**A12 CHELMSFORD TO A120 WIDENING SCHEME – TR010060
DEADLINE 4 SUBMISSION – RESPONSE TO EXQ2 Q2.5.14
ROYAL LONDON UK REAL ESTATE FUND AND EDMUNDSON ELECTRICAL LIMITED
11 APRIL 2023**

Exploded View - NTS

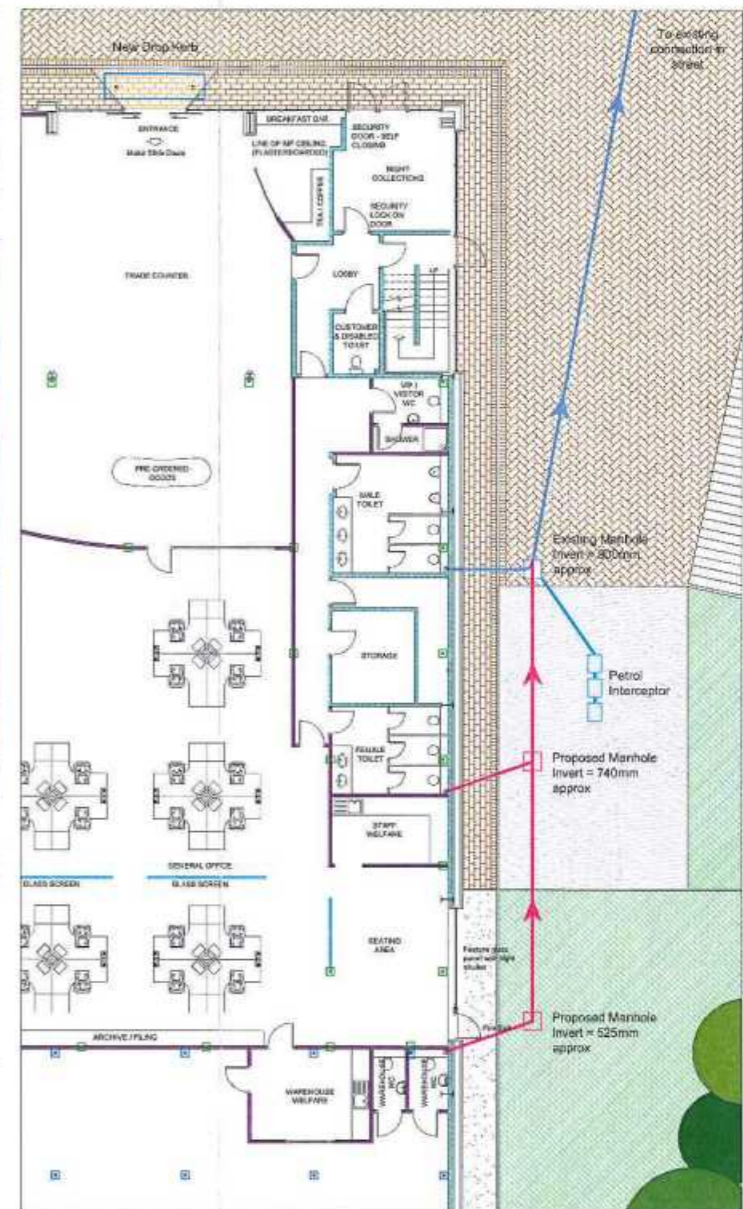
- 2.15. During the site visit the location of a run-off tank (believed to be for petrol or oil) beneath the Applicant's proposed access route was raised. A plan showing the location of this tank is included at Appendix 1.
- 2.16. Royal London and EEL consider that it will be necessary to investigate this further as there are likely to be weight restrictions in this area preventing the Applicant and Cadent using the access for the purposes required and the issue does not appear to have been considered previously. Royal London and EEL are of the view that investigative work should be undertaken by them at the Applicant's cost to determine the position. Royal London and EEL have raised this with the Applicant but wanted to draw it to the attention of the Examining Authority.
